Called 9/27/99

Facility: Nine Mile Point # 2Date of Examination: 12/06/99Examination Level (circle one): ROOperating Test Number: Cat A Test 1

Nine Mile Point 2	
Category "A" - Examination Outline Cross Reference	
Operating Test Number	Cat "A" Test: 1
Examination Level	RO
Administrative Topic	A.1
Subject Description:	Shift Turnover
Question Number:	1

Turbine Building 277

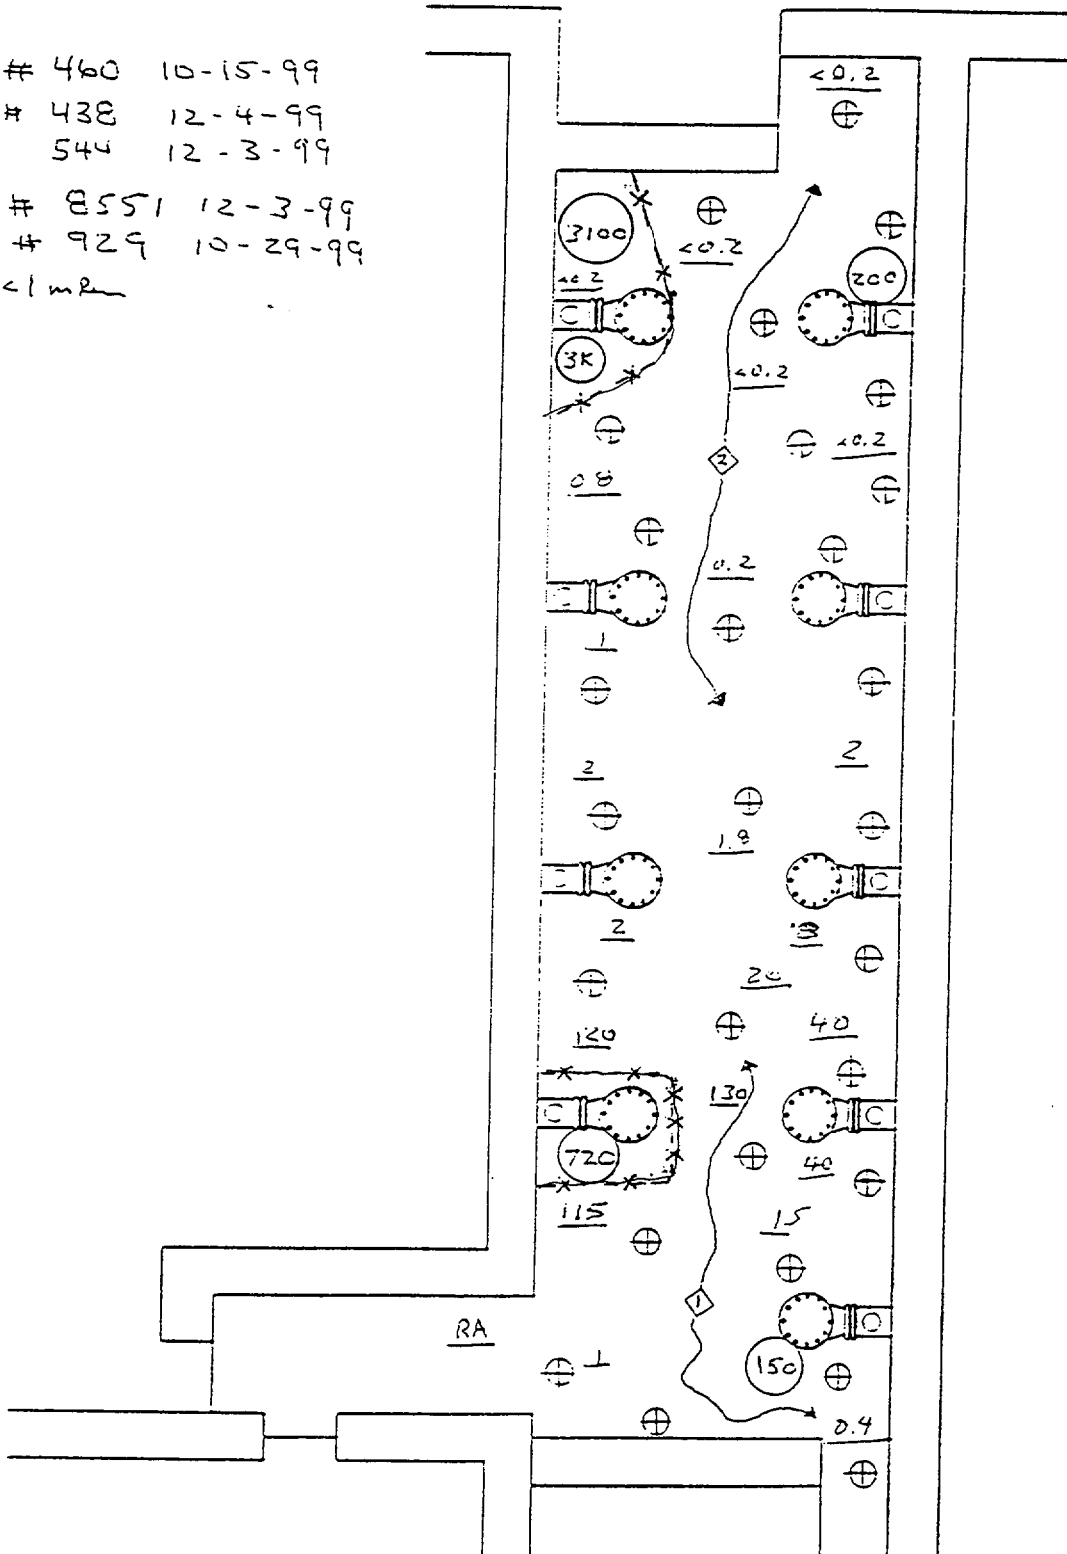
Question:
Review the attached Survey 68 for Turbine Building 277' Condensate Demin Valve Aisle and identify the radiological hazard(s), <i>if any. ??</i>

Answer:
<p>a. Contaminated areas identified by lines with Xs on the left hand side of the room with contamination levels of (from bottom of page) 720dpm/100cm², 3000dpm/100cm², and 3100dpm/100cm².</p> <p>b. High radiation levels in the bottom left hand side of the Valve aisle with radiation levels of 115mr/hr, 130mr/hr and 120 mr/hr. <i>"All rad levels are radiological hazards."</i></p>
